**STAFF REPORT**  
**COMMUNITY DEVELOPMENT DEPARTMENT**

HEARING DATE: 4/2/2024  
 TO: Mayor & City Council  
 FROM: Sonya Allen, Associate Planner  
 208-884-5533  
 SUBJECT: SHP-2024-0001  
 Watts Meridian Medical Partners  
 LOCATION: 1256 S. Rackham Way, in the SW 1/4 of  
 Section 16, T.3N., R.1E. (Parcel  
 #R6819240215)

A short plat is proposed consisting of two (2) building lots on 2.53-acres of land in the C-G zoning district for Watts Meridian Medical Partners Subdivision.

## A. Short Plat (date: 1/11/24)

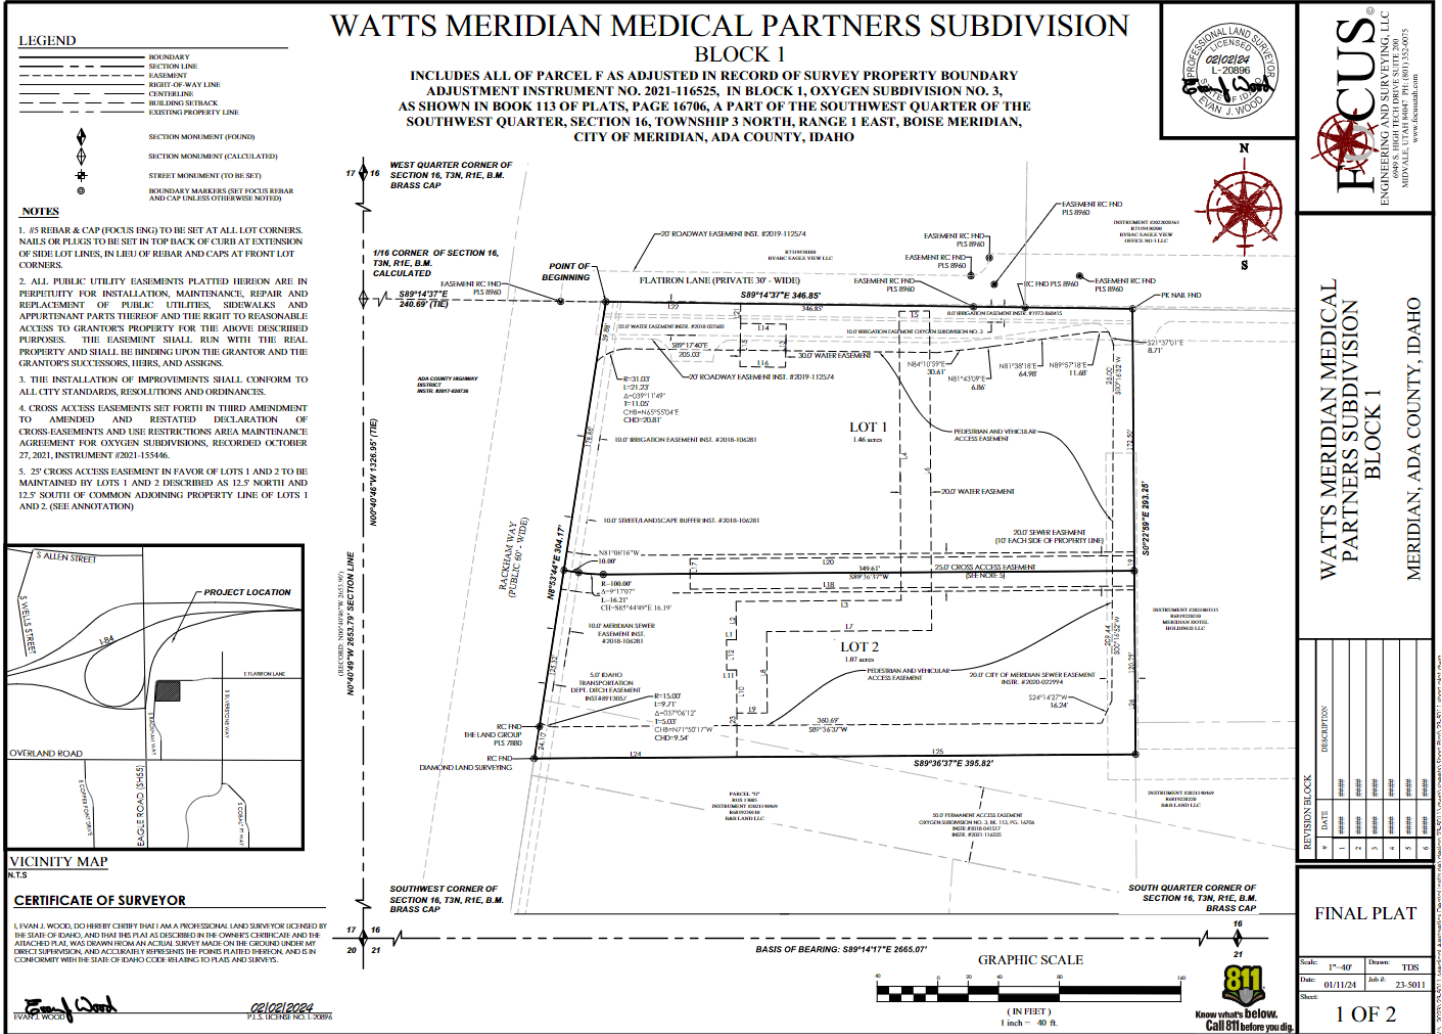
3. The short plat prepared by Focus Engineering and Surveying, LLC on 2/2/2024 by Evan J. Wood, included in Section VI.A, shall be revised as follows:
  - a. Depict pavement widening for Rackham Way and curb, gutter and sidewalk as required by ACHD; additional right-of-way may be required to be dedicated.

- b. If the existing street buffer easement along Rackham Way is affected by the pavement widening required by ACHD, amend the easement and the plat accordingly. A minimum 10-foot wide street buffer should be provided measured from back of sidewalk if an attached sidewalk is provided, or back of curb if a detached sidewalk is provided, in accord with UDC [11-3B-7C](#)

- c. Amend the 50-foot wide permanent access easement (Inst. #2018-041517, Inst. #2021-116525) that crosses the southwest corner of the site recorded with Oxygen Subdivision No. 3 to exclude the area included in the proposed plat.

LANDSCAPE PLAN

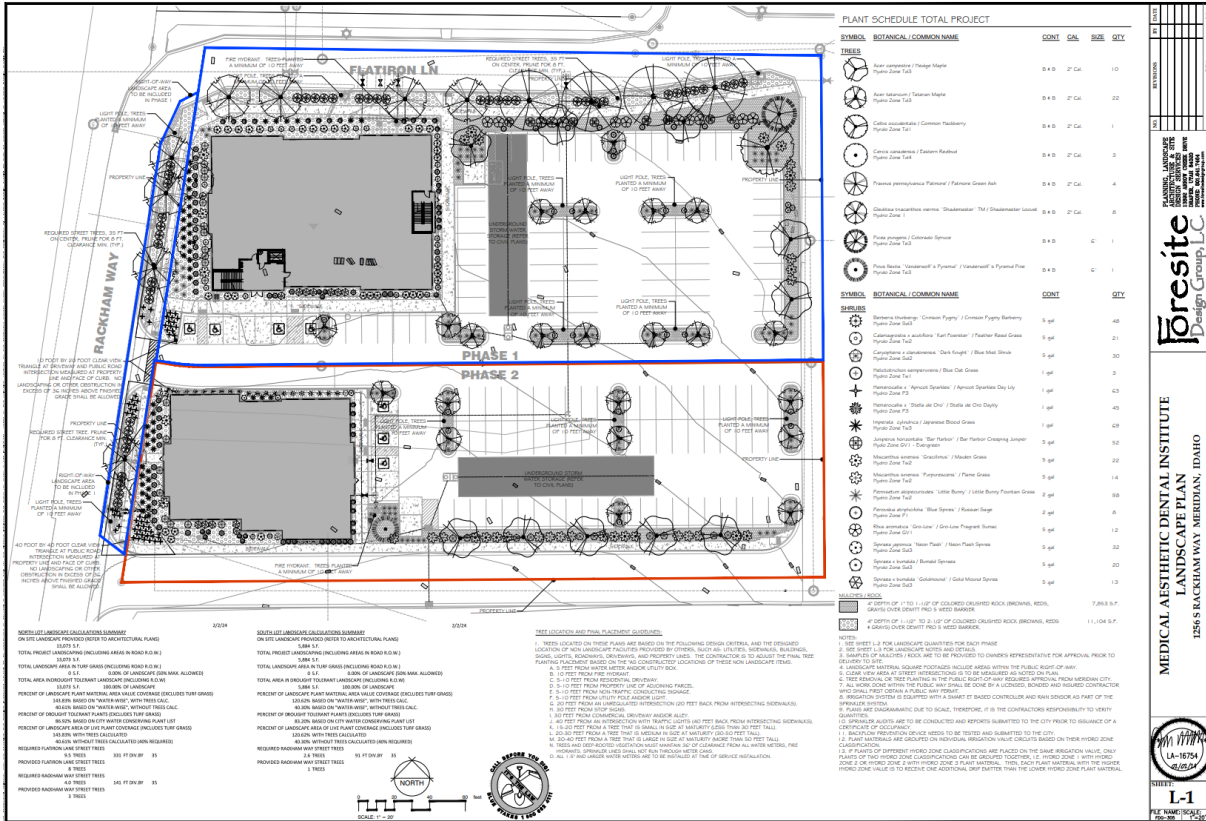
4. The landscape plan prepared by Foresite Design Group shall be revised as follows:
  - a. A minimum 10-foot wide street buffer is required along S. Rackham Way, measured from back of sidewalk if an attached sidewalk is provided, or back of curb if a detached sidewalk is provided, in accord with UDC [11-3B-7C](#). *If additional right-of-way is required for pavement widening of Rackham Way, adjust the location of the buffer accordingly.*

- b. Depict a minimum of seven (7) trees within the street buffer along Rackham Way in accord with the standards set forth in UDC [11-3B-7C](#) (see allowed landscaping in clear vision triangles in UDC [11-3A-3B](#)). *At least 35% of qualifying trees must provide urban canopy at maturity, and at least twenty-five (25) percent of qualifying trees must be Class 2 selections, unless it can be shown that utility conflicts prohibit installation of Class 2 trees.* If trees are not allowed within the existing easements, a minimum 5-foot wide area for planting trees and shrubs shall be provided outside of the easement area as set forth in UDC [11-3B-7C.1b](#).
